UNITED STATES PATENT AND TRADEMARK OFFICE

Office Action Summary

10/810,297

DETAILED ACTION

FIG.3I

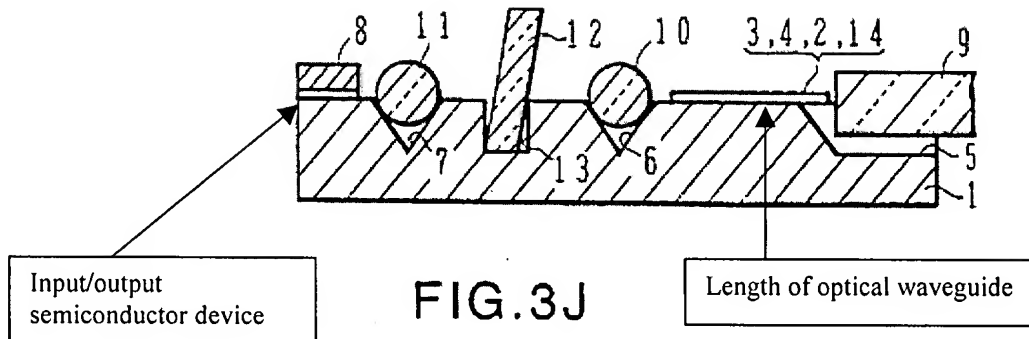
Claims 12-14, 17 and 24-26, in the referring figures, the round elements (10, 11) are ball or spherical lenses contained in a pyramidal hole (6a-6e and 7a-7e), fiber (9) is supported by a v-groove (5). The examiner respectfully point out that the assembly of two convex lenses facing

FIG.3J

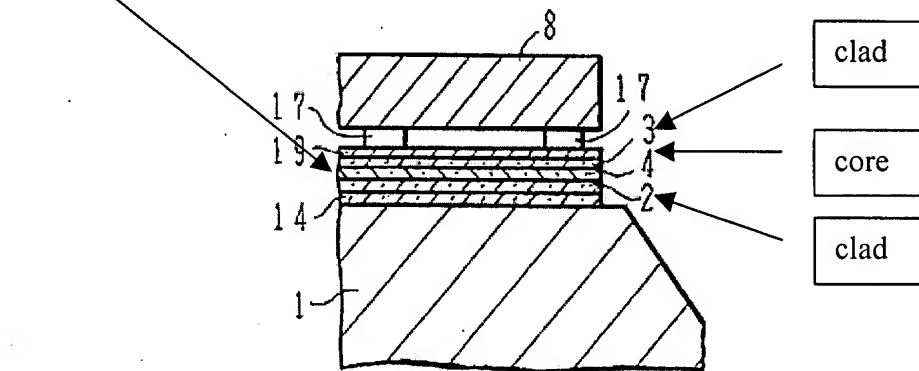
Claims 9-11, and 21-23, referring to Fig. 3J and see col. 8, lines 20-22 wherein Tabuchi discloses the optical member (12) may form an optical isolator by applying a thin laminated layer upon the substrate of the rectangular optical member (12). The examiner would like to point out that an optical isolator is a one-way filter for a range of light frequencies. Regarding claim 22, this is a functional limitation within a device claim, thus the limitation retains no patentable weight.

FIG. 2A

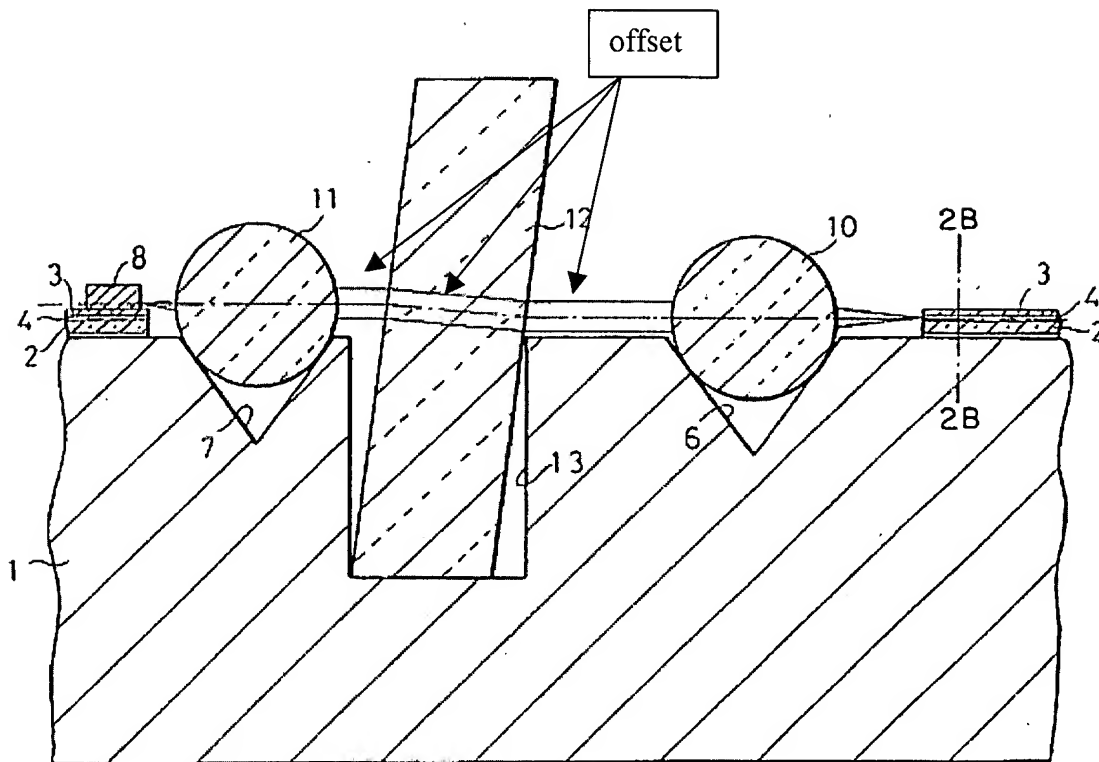
Regarding claims 1 and 15, Tabuchi discloses a mounting arrangement comprising a substrate (1), referring to Fig. 2A, 2B, and 6, an input optical fiber (9) associated with said substrate an output optical waveguide ('2' '3' '4') in a given set of planar layers of said output waveguide wherein the output waveguide and the further optical waveguide are aligned along an input-to-output propagation path, thereby providing substantial alignment of said output optical waveguide and said further optical waveguide, said further optical waveguide is interposed between said input optical fiber and said optical component (ball lens 11, isolator 12, or ball lens 10) and wherein said optical component is interposed between said further optical waveguide. Furthermore, Tabuchi teaches an input/output optical semiconductor device (8) further comprising a waveguide ('2' '3' '4'). Since the core and the claddings of the two segments of waveguides are referred to with the same numeric reference, for differentiating purposes the output waveguide will be referred to as (8) and the length of optical waveguide will be referred to as (14). The length of optical waveguide (14) on said substrate in the same planar layers of said output optical waveguide (8), the length of optical waveguide is interposed between the input optical fiber (9) and at least one optical component (10, 12, 11) so that at least one optical component is interposed between the length of optical waveguide and the output optical waveguide. Furthermore, the Abstract clearly teaches the mounting of the fiber on the substrate via the v-groove.

Regarding claim 8 wherein the end surfaces of the output waveguide and the length of optical waveguide are offset to a perpendicular to input-to-output propagation path and a propagation path of radiation through at least one optical component is at an angle with respect to the input-to-output propagation path.
